Building Code of Australia

Assessment Report

**Project Address: Gillieston Public School
redevelopment and new public preschool**

Report Number: RE220628

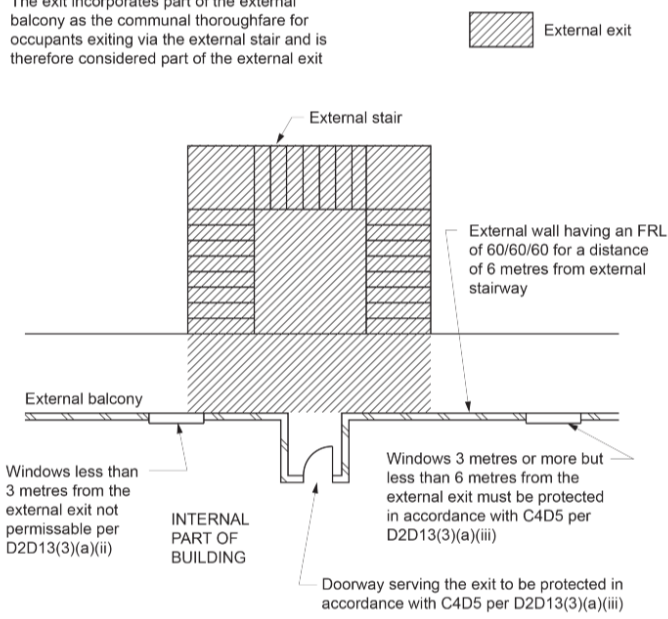
BCA Clause	Assessment and Comment	Status
Part D1 Access and Egress		
NSW D2D3 Number of exits required	Not less than 2 exits are required to any storey in a Class 9b early childhood centre and to each storey in a primary school with a rise in storeys of 2 or more. Otherwise in a Class 9b building any storey that accommodates more than 50 persons is required to have two exits.	Performance Solution

BCA Clause	Assessment and Comment	Status
	<p>The above requirements do not apply to a part of a storey that-</p> <ul style="list-style-type: none"> (i) is a plant room, machinery room, storeroom, lift-machine room or the like; (ii) is provided with direct egress to a road, open space or a fire-isolated exit complying with D2D12(2); and (iii) satisfies D2D5 by the provision of 1 exit. <p>Therefore, all buildings are required to be provided with a minimum of two exit(s).</p> <p>Building BC has four levels that are at no part more than 3 storeys above each other and egress is staggered over the levels to part.</p> <p>The following areas do not comply with DTS provisions are concessions within this clause:</p> <p><u>Lower Ground</u></p> <p>Building BC: Sanitary provisions only have one exit</p>  <p>Building BC: The mech plant room LG.01 is able to comply with DTS exemption for access to 2 exits however the Main Comm LG01 PS402.03 and air lock PS403.02 do not have access to 2 exits</p>

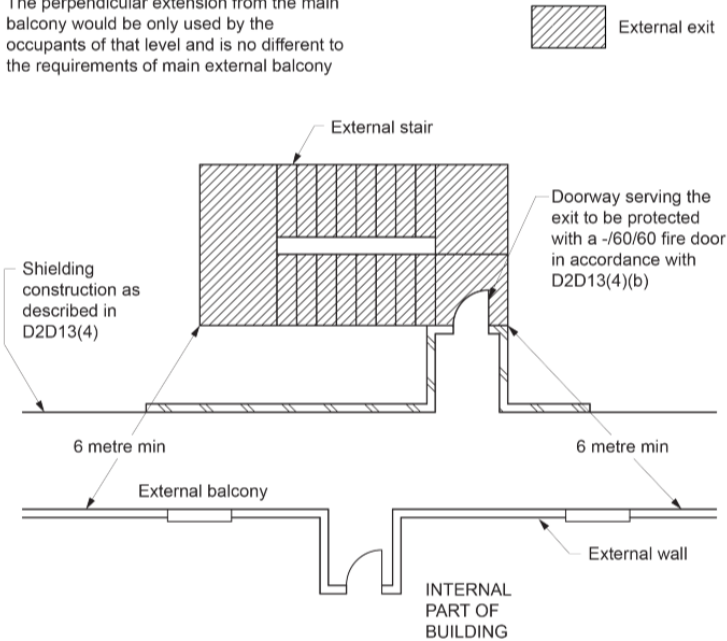
BCA Clause	Assessment and Comment	Status
	 <p><u>Ground Level</u> Building BC: Sanitary provisions only have one exit</p>  <p>Building BC: SLISO office 01 PS 102.06 & staff WC do not have access to 2 exits</p>

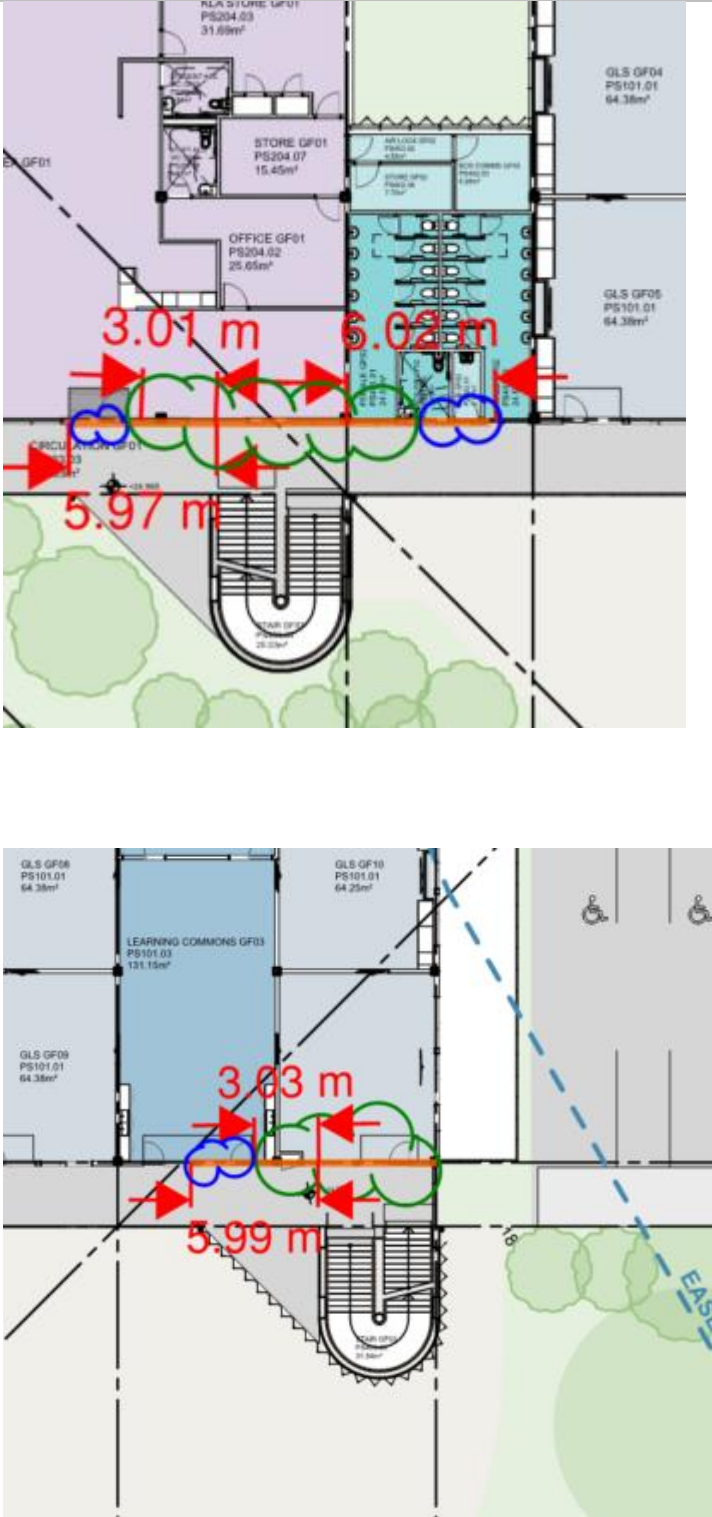
BCA Clause	Assessment and Comment	Status
D2D10 Exit width not to diminish in direction of travel	The unobstructed width of a required exit must not diminish in the direction of travel to a road or open space, except where the width is increased in accordance with D2D8 (1)(b) or D2D9(a)(i).	Capable of Complying
D2D11 Determination and measurement of exits and paths of travel to exits	The required width of stairs and ramps is to be measured in accordance with this clause.	Capable of Complying
D2D12 Travel via fire isolated exits	The stairs to Building BC are required to be fire-isolated however as they are external stairs they have been assessed as external stairs or ramps in lieu of fire-isolated exits.	Note
D2D13 External Stairs or ramps in lieu of Fire-isolated exits	<p>Building BC has external stairs provided in lieu of fire isolated exits. The design of external stairs in lieu of fire-isolated stairs still intended to provide an equivalence of fire isolation. For prescriptive compliance the following design principles are to be followed:</p> <ul style="list-style-type: none"> (1) Stair to be non-combustible throughout and protection within 6m of the external wall of the building it serves. (2) Protection to be provided as follows: <ul style="list-style-type: none"> (a) the part of the external wall of the building to which the wall is exposed must have- <ul style="list-style-type: none"> (i) external wall of the building should have an FRL not less than 60/60/60 (ii) no openings less than 3m from the exit (except a -/60/30 fire door serving the exit in accordance with C4D19(1)) (iii) Openings 3m or more but less than 6m should be protected in accordance with C4D5) and if wall wetting sprinklers are used they should be located internally <p>NCC 2022 guide indicates this protection described in (2)(a) as below:</p>	Performance Solution

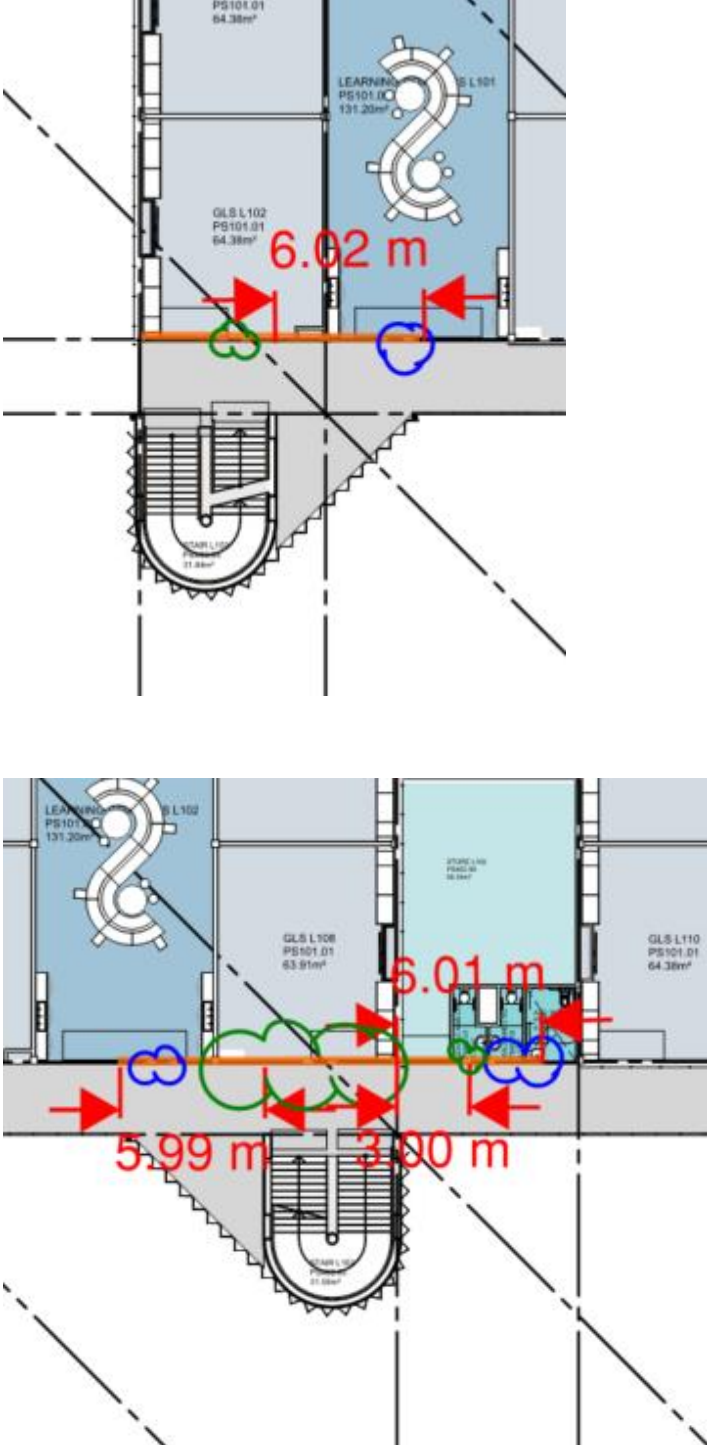
BCA Clause	Assessment and Comment	Status
	<p>The exit incorporates part of the external balcony as the communal thoroughfare for occupants exiting via the external stair and is therefore considered part of the external exit</p>  <p><u>OR</u></p> <p>(b) the exit must be protected by construction of a wall, roof, floor or other shielding element from any part of the external wall of the building having an FRL of less than 60/60/60 and any openings in the external wall. The wall, roof, floor or other shielding element must -</p> <ul style="list-style-type: none"> (i) have an FRL of not less than 60/60/60; and (ii) have no openings less than 3m from the external wall of the building ((except a -/60/30 fire door serving the exit in accordance with C4D19(1); and (iii) have any opening 3 or more but less than 6m from any part of the external wall of the building in accordance with C4D5 and wall wetting sprinklers should be located on the side exposed to the external wall <p>NCC 2022 guide indicates this shielding protection described in (2)(b) as below:</p>

BCA Clause	Assessment and Comment	Status
	<p>The external exit is considered to be any part of the stair that would be used by any occupant travelling down the stair. The perpendicular extension from the main balcony would be only used by the occupants of that level and is no different to the requirements of main external balcony</p>  <p>The following areas in particular should be clarified for DTS compliance or a performance solution provided by a suitably qualified fire engineer as appropriate. Please note the comments below have considered protection as in (2)(a) above:</p> <ol style="list-style-type: none"> All external walls to the within 6m of the exit (external stairs – nearest part of landing) are required to achieve an FRL of 60/60/60. Where this can not be achieved a Performance Solution may be appropriate. See snips provided below for areas that are required to be 60/60/60 highlighted in orange line. Openings located within 3m of the exit (external stairs – nearest part of landing) are not permitted. These are indicated in green cloud in snips below. A performance solution would be needed. Openings located more than 3m but within 6m of the exit (external stairs nearest part of landing) can be protected in accordance with C4D5. Alternatively, a performance solution may be achievable. The openings affected are indicated in blue cloud in snips below. <p>Where protection is provided in accordance in (2)(b) above, further advice can be provided after the shielding device is shown as proposed.</p>
